Access Compliance Report Public Rights-of-Way (Curb Ramps)

Main Street: MARTHA_ANN_DR Cross Street: WALKER_LEE_DR Location: NE

ADA ID: RPRK211207121009 Ramp Type: Type 1 - Perpendicular Diagonal Initial Pass/Fail: Pass Overall Compliance: No Severity Score: 20

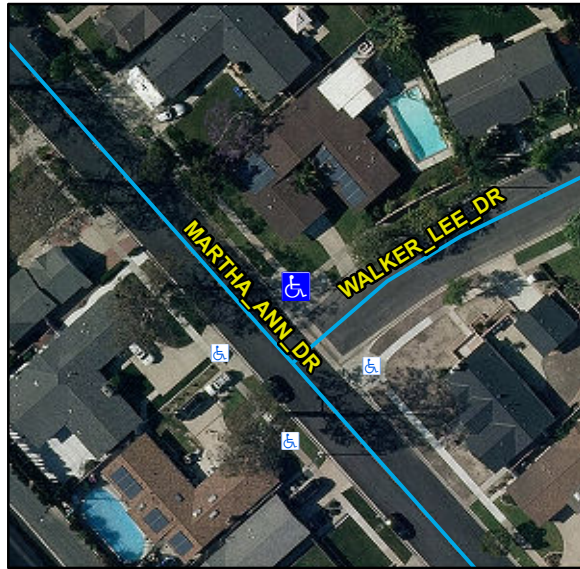
Remove & Replace Curb Ramp With Two New Directional Ramps or Equivalent. Remove & Replace Gutter.
